**ELGEMS**

TO : Seung Lee – NRC fax 301-415-5369  
FROM : Sergio Steinfeld – Elgems  
CC : Jim Beebe – GEMS fax 414-548-5197

The letter bellow provides the required information you asked in your E-mail of 3/10/99.  
The answers are in bold letters just after your question.  
The following appendices are attached

- page 3-3 & 3-4 of the MG ATC Operation Manual.
  - Sketch drawing named : MG ATC Rod Unit – Removing the Brass Filter
  - Engineering Drawing No. LBL-000424-01 Warning Label

Figure 3-1. Transmission Source Mask

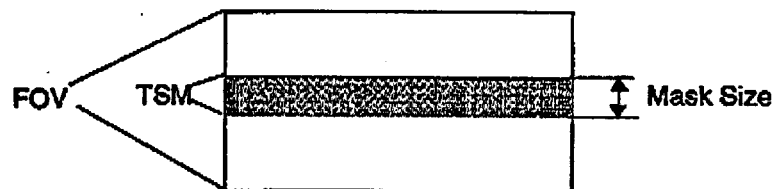
1. Please provide more detailed description for the transmission scan mask on page 3-3 in MG ATC Operational Manual. There are no Figure 3-4 and Table 8-1 as specified. Why is thallium used in example? Is this used in this Rod Unit as a sealed source?

- a) **Attached updated pages 3-3/4 with detailed description for the transmission scan mask. If you are satisfy, let me know and I send you all the updated MG ATC Operation Manual Rev 2.0.**

The transmission scan mask (TSM) defines an acquisition region which moves synchronously with the opposite transmission line source across the detector field of view. (See Figure 3-1)

The transmission image acquires only events which are in the 100 keV energy window corresponding to the  $Gd^{153}$  transmission energy, and also inside the mask (Figure 3-1)

# MG ATC Rod Unit – Removing the Brass Strip Filter

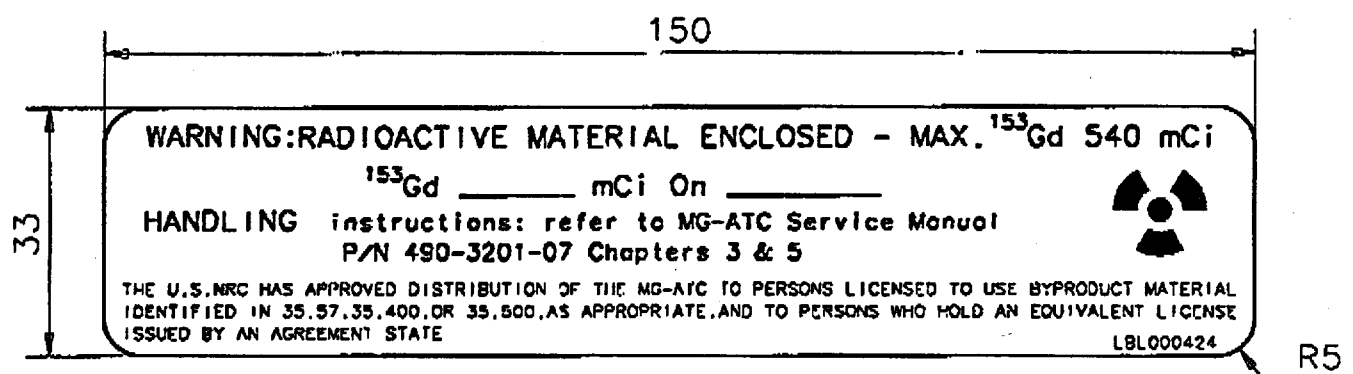
2. In the description of radiation safety feature of device, you stated that "The rod source Gd-153 is sealed with the exposed end having an additional 3.0 mm brass filter strip which reduces the equivalent source activity to 244 mCi for scanning purposes and extends the source life." Please provide the methodology how to extend the source life. How is the brass strip removed and what is its frequency?

**The ATC Rod Unit contains the Gd-153 radioactive source with half life time of 242 days. The initial nominal activity of the source is 450 mCi. At the time of the option installation, an additional 3.0 mm brass filter strip is used, which reduces the equivalent(effective) source activity to 244 mCi for scanning purposes. After approximately one half life time, the filter strip is removed. This allows the full strength of the remaining activity to be used for an additional half life, thus extending the useful life of the source. After one year from the source installation, the source should be renewed and the filter strip is placed back.**

The procedure of removing the filter does not require to disassemble any part of the rod unit and takes a few minutes. The filter is located on the external side of the Rod Unit in front of the collimator (See the drawing attached). During the procedure, the shutter is in its close position. The procedure includes the following simple steps:

- a) Unscrew the locking screw on the rod unit.
- b) Remove the brass strip by sliding it out.
- c) Return and screw the locking screw.
